Conceptual Review Agenda

Monday, February 1, 2016

1303 Plum St Multi-family

CONCEPTUAL REVIEW: APPLICATION

ARCHITECTURAL SITE PLAN

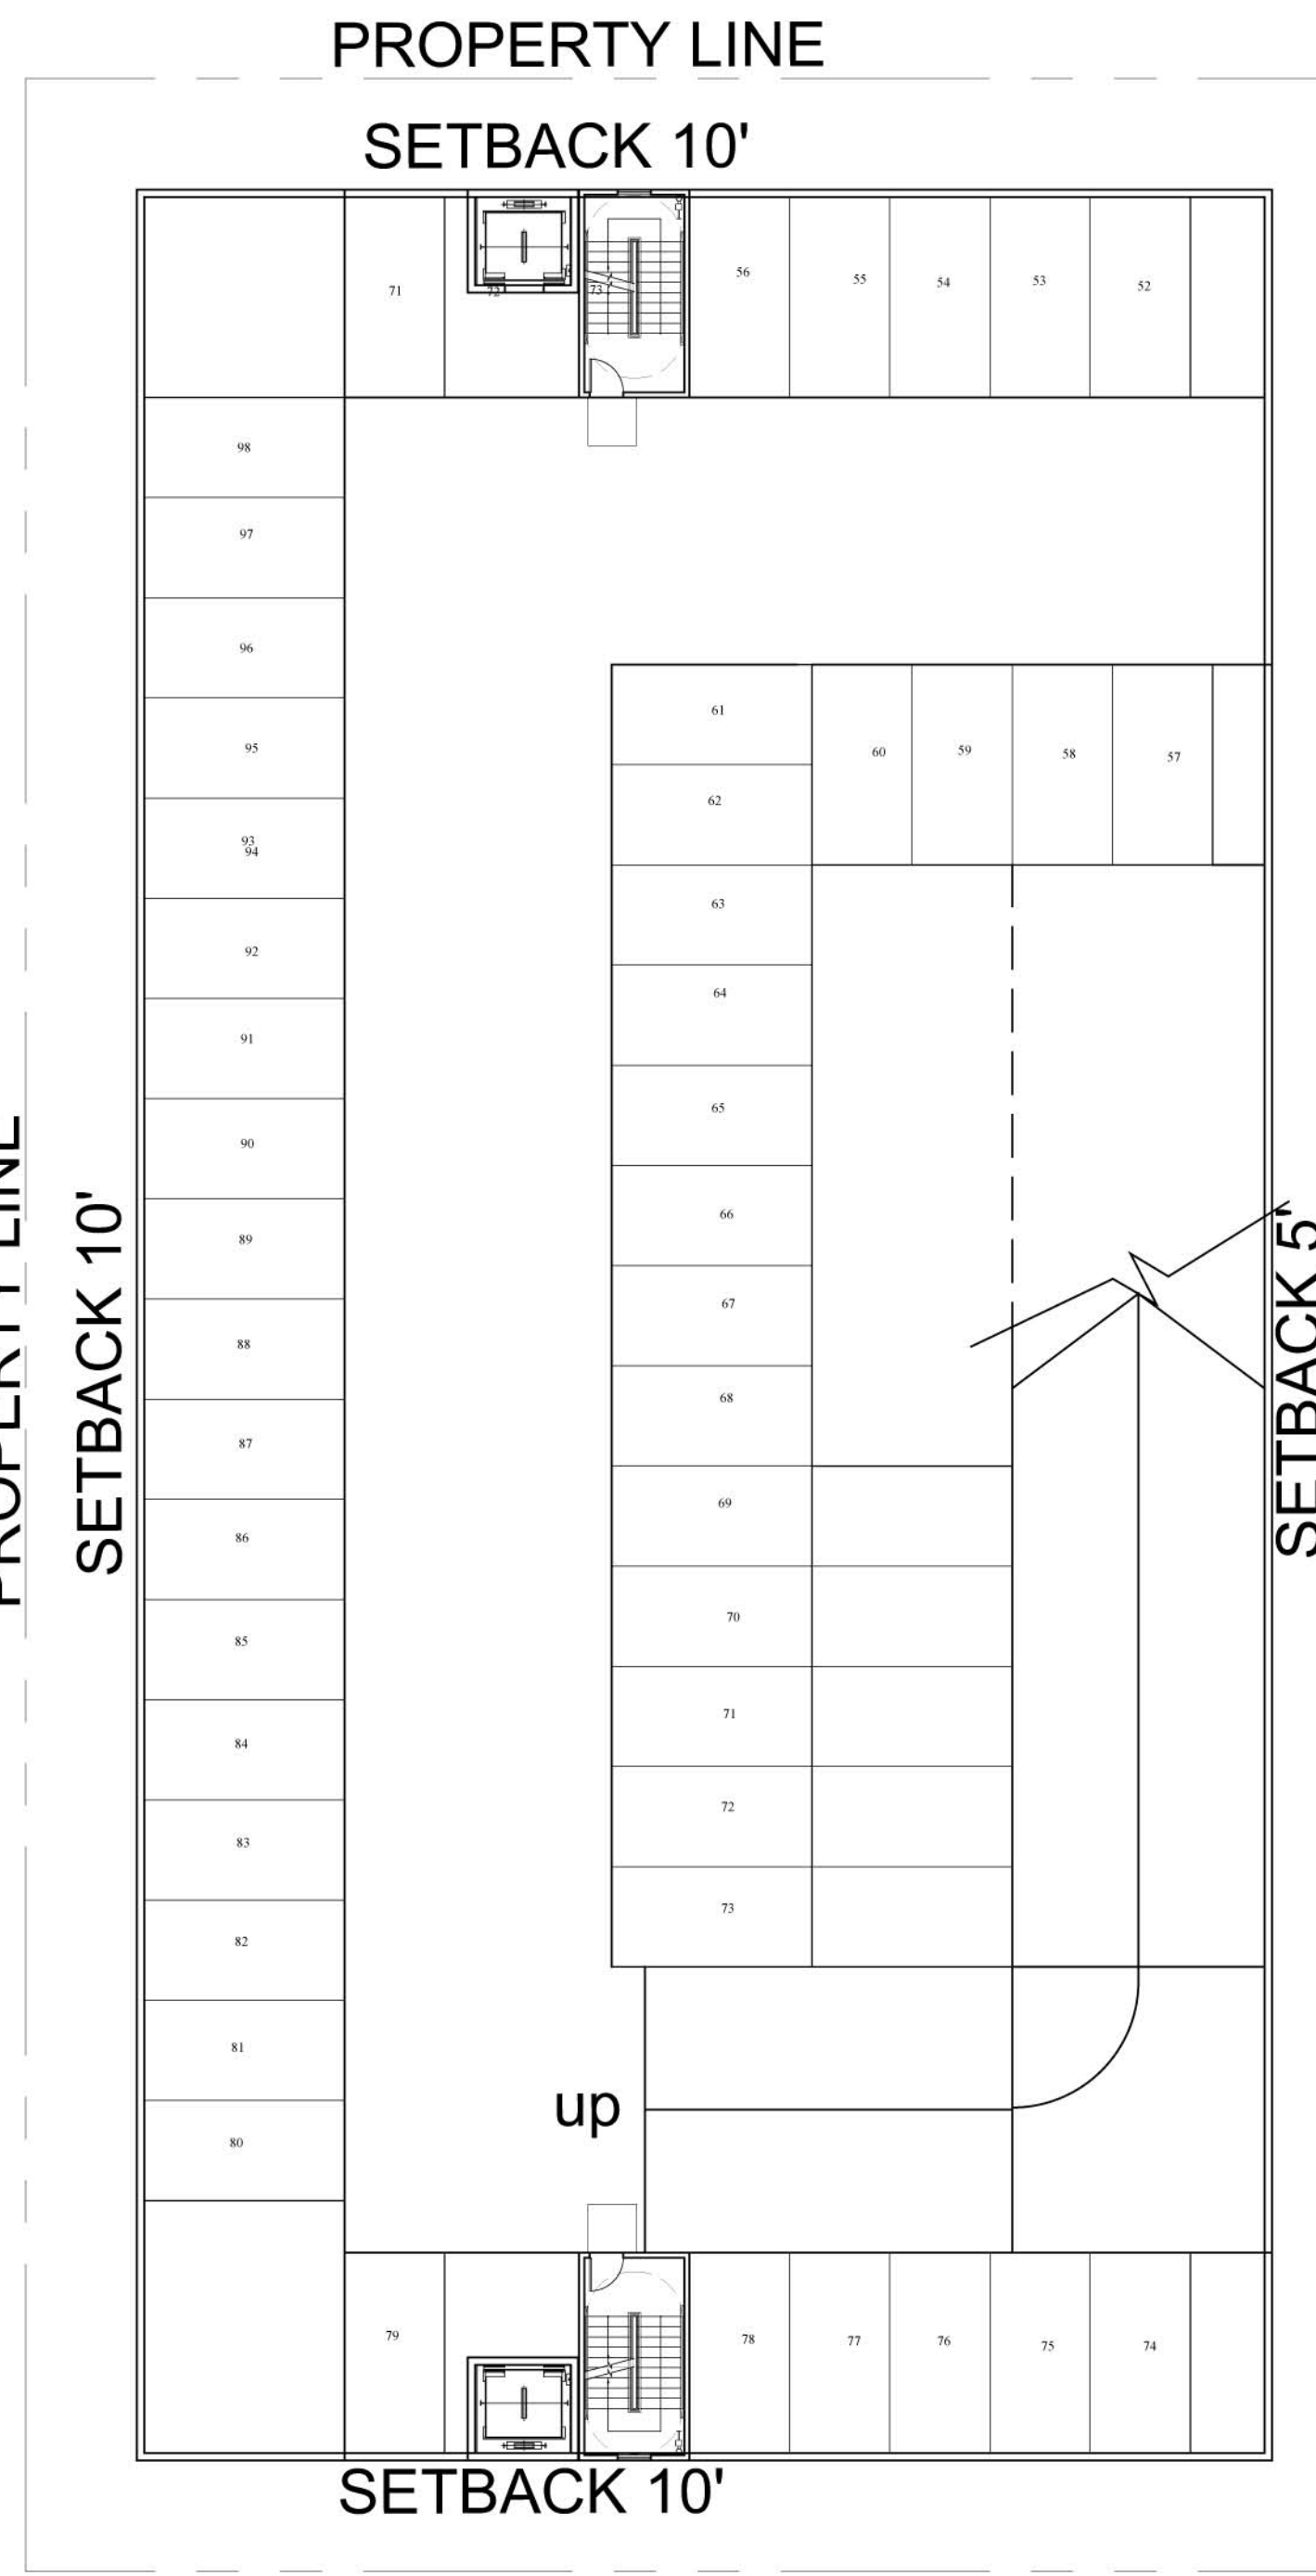
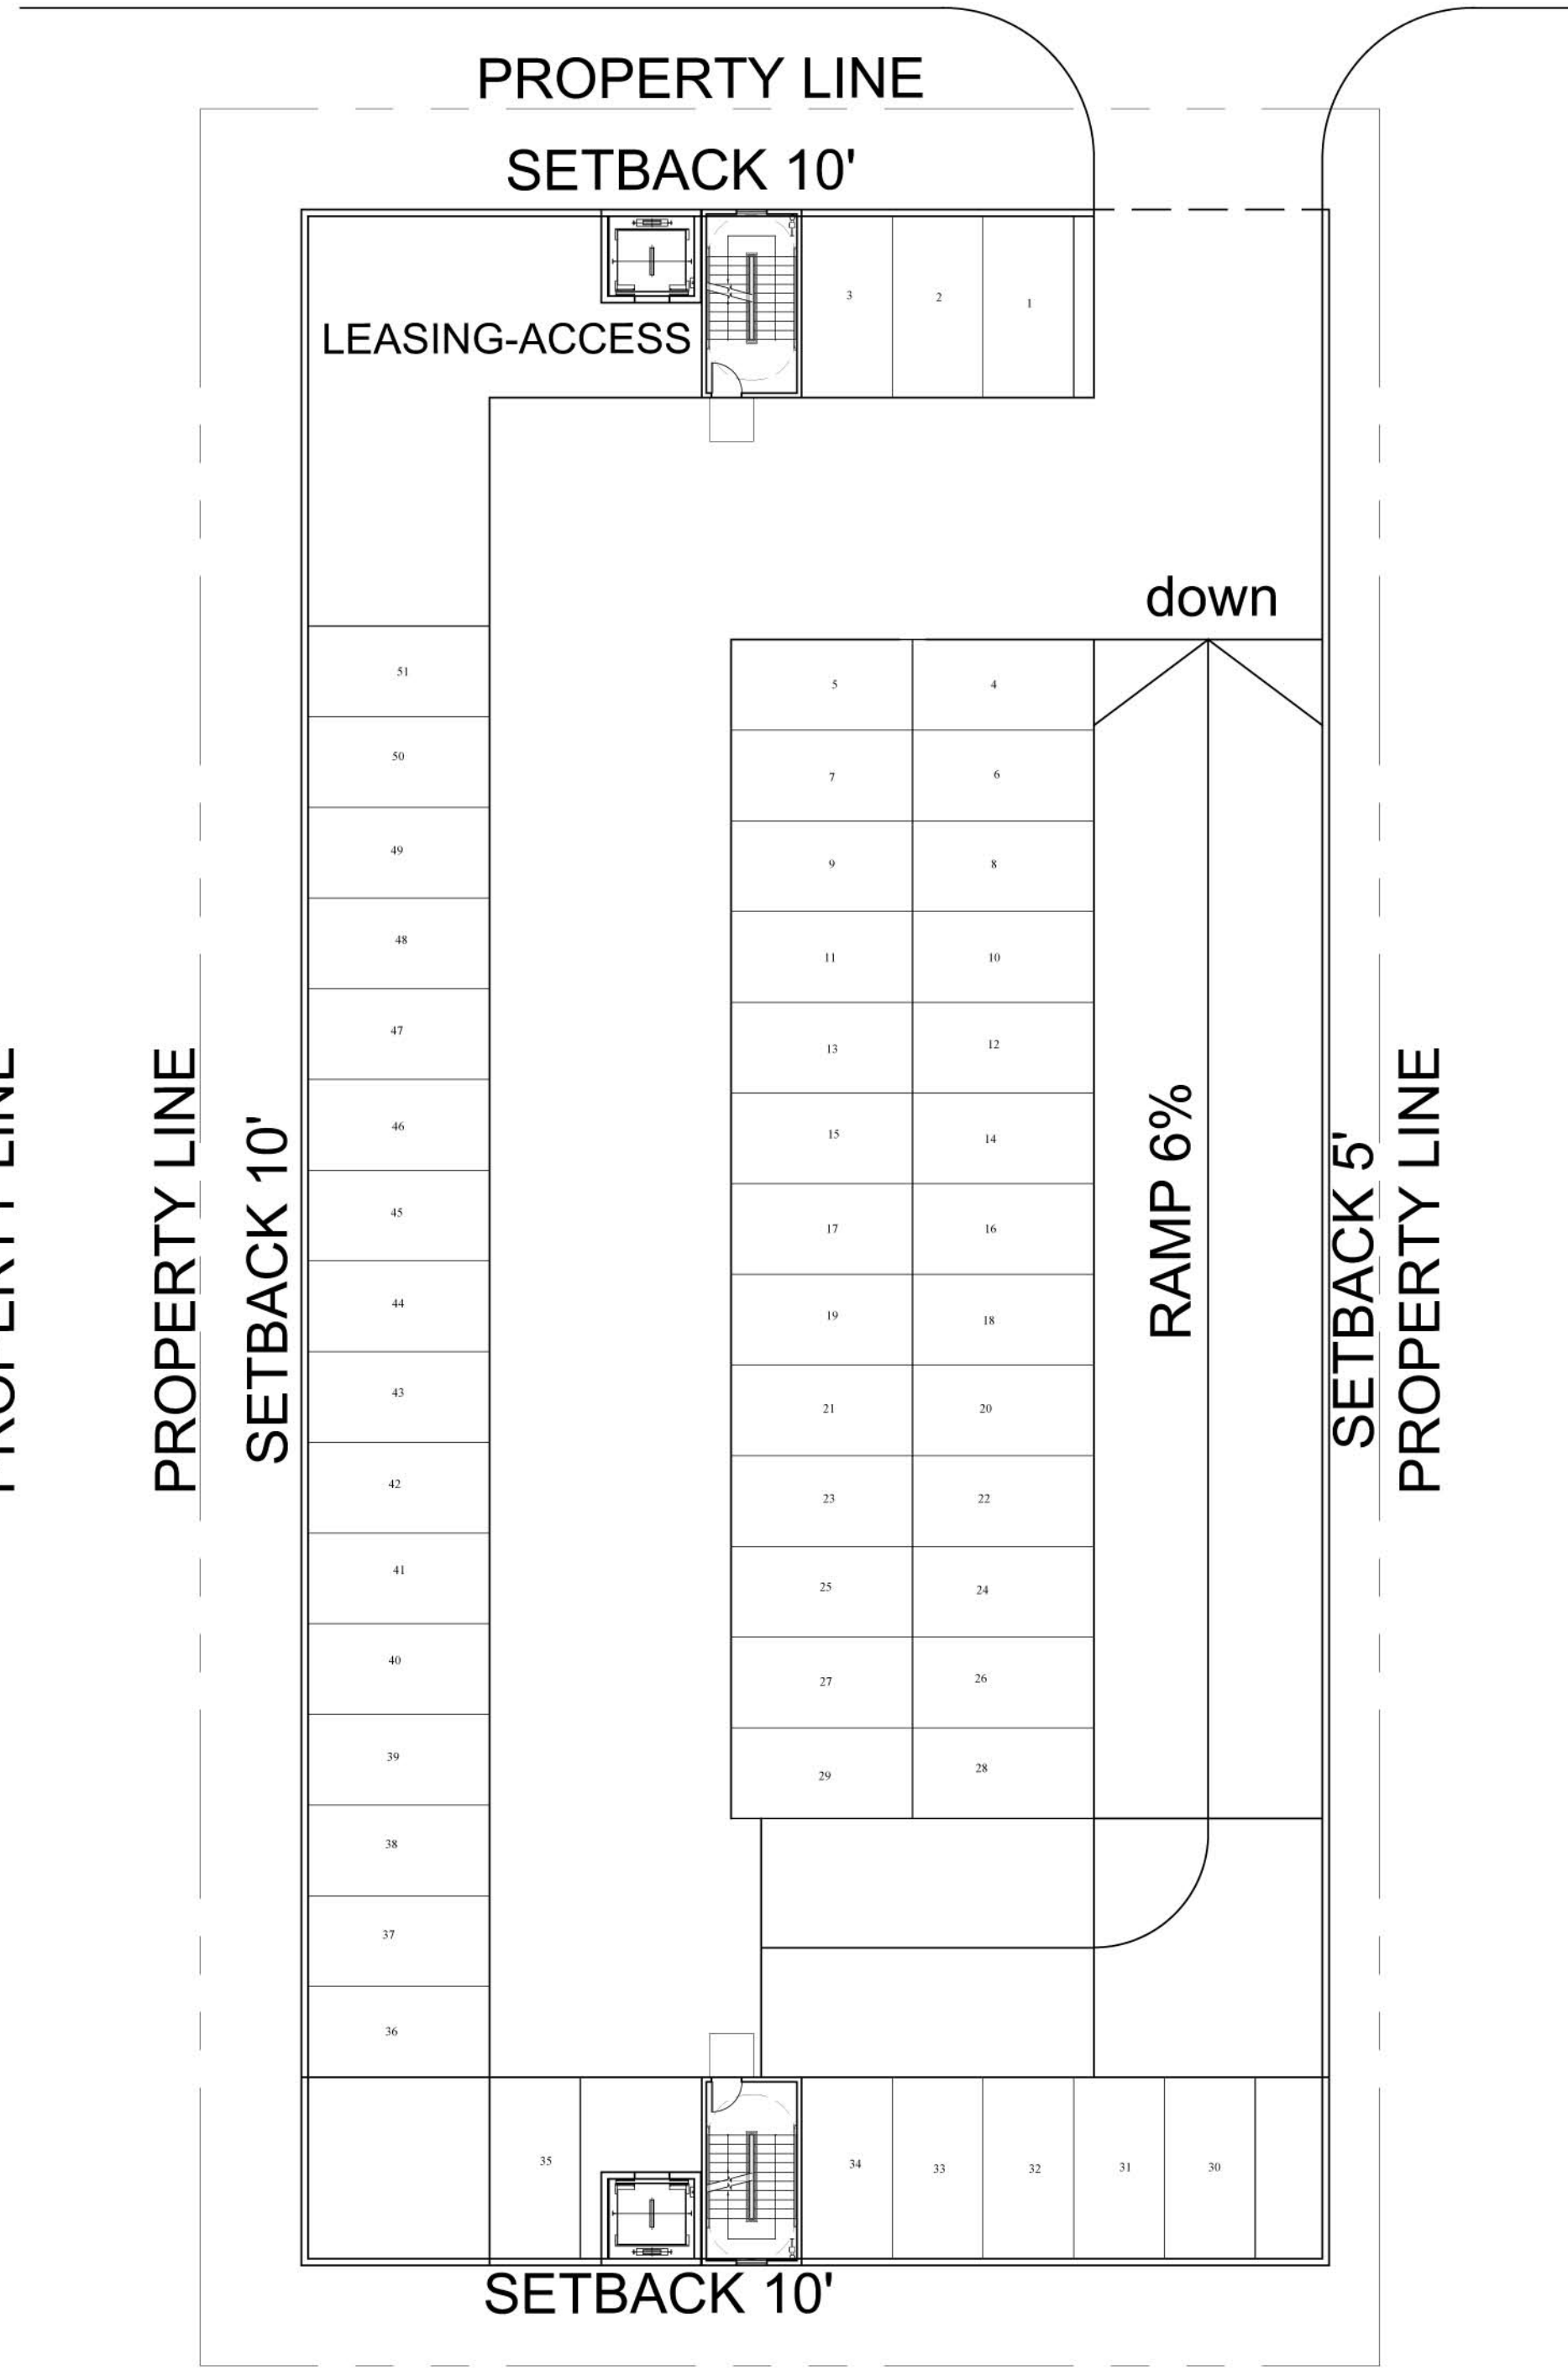
1. If the plan is to rent by bedroom then a minimum 103 off-street parking spaces are required per the TOD parking requirements. If renting per dwelling unit then 56 off-street vehicle spaces are required per TOD requirements. Proposed plan shows 98 off-street parking spaces. Please refer to LUC 3.2.2 for parking regs.

5. The plans need to show mechanical equipment (vents, flues, RTU, meters, electric boxes, conduit) locations and how these are screened
6. A lighting is required. This is a photometric site plan with catalog cut-sheets of the proposed fixtures.

Fire access is required to within 150' of all exterior portions of the building perimeter. Calculating accessibility from Plum Street leaves the building approximately 230' out-of-access. The out-of-access condition can be reduce to approximately 50' if a cross access easement can be established with the property to the east, but that drive aisle will also be required to be dedicated as an EAE and meet minimum fire lane standards and provide a turnaround. See also PFA comment #3 (below) for specific fire lane requirements pertaining to buildings greater than 30' in height. Code language and fire lane specifications provided below.

Buildings exceeding 30' in height are required to meet aerial fire apparatus access requirements as per 2012 IFC Appendix D. In such cases where site limitations do not allow the code to be met, the fire marshal will allow the project team to present a formal plan for meeting the intent of the fire code via means of alternative compliance. Such a plan is required to be presented in writing for review and approval prior to issuance of a building permit. Code language provided below.
